Case Study #4: Floor System Analysis

Client: Heritage Homes of Jacksonville, Jacksonville, Florida

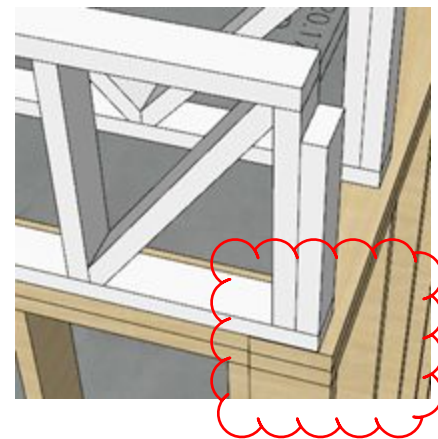
The foundation walls were modeled per the architectural drawings. The floor truss model, provided by client, was imported into the foundation model and trusses were placed on the top plate at one corner. The first discovery, in verifying alignment around the entire house, was a very common mistake/issue - when the trusses were snapped to the plate on the front of the house, they were 1" short from flushing out with the back wall framing. The truss engineer assumed that the dimensions specified in the architectural plans were "sheathing to sheathing", so $\frac{1}{2}$ " was taken off each end to allow for sheathing. This is a common practice, however the architectural plans dimensions referenced "framing to framing". Every builder has probably dealt with this sort of issue (too short or too long) at some point in time, and has had to spend time and money correcting them in the field. We prevented that from occurring.

Trusses were placed flush with framing on front wall

Trusses were 1" short on rear plate

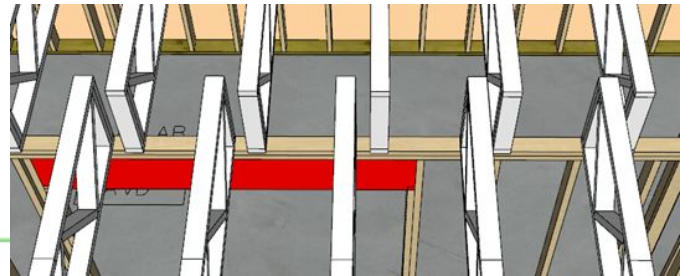
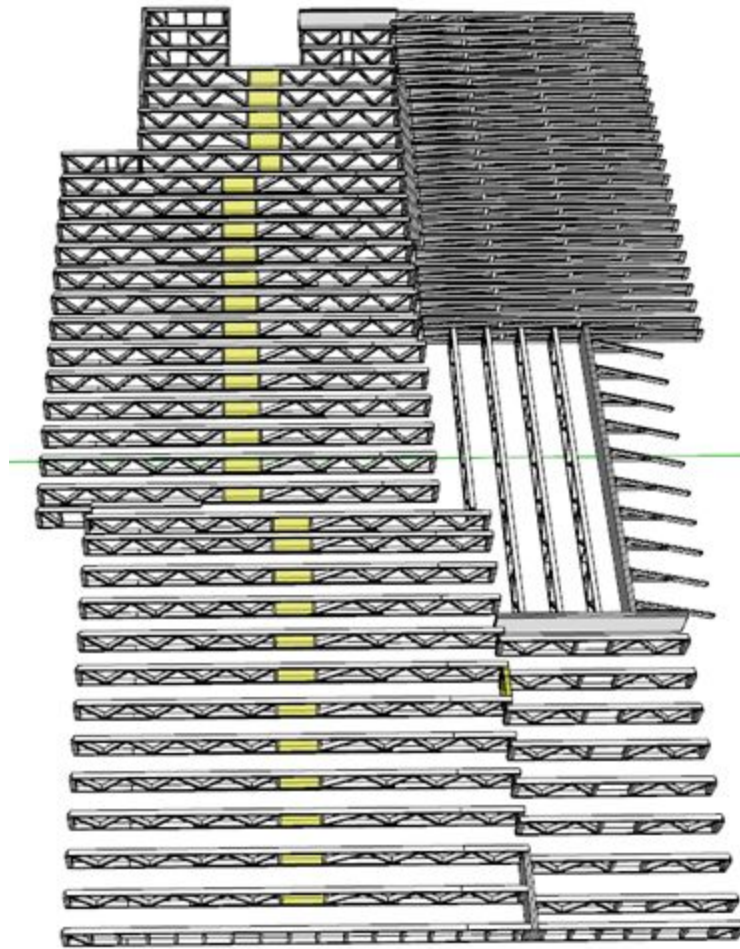
The next discovery, obvious when looking at a 3D representation of the trusses, vs a 2D drawing, was that the HVAC duct chases were not aligned. Floor trusses commonly have rectangular chases in the center portion of the truss. Many times, when a house has a bump out or recess, the trusses are engineered by default to center the chase - this situation impacts the HVAC ductwork placement.

Notice below how the chases are not aligned. There was another issue discovered as well. The garage includes a partition wall (bearing wall) between the garage and the storage and mechanical room at the rear of the garage. The HVAC system was intended to be placed in this room and the

supply duct was to go up, over the wall and into the duct chase. The truss engineer had laid out the floor trusses with staggered trusses from partition to rear wall. This would have essentially eliminated a path for the ductwork. When

the builder showed the HVAC contractor these images, he basically was told that the house was “not ductable as is”.
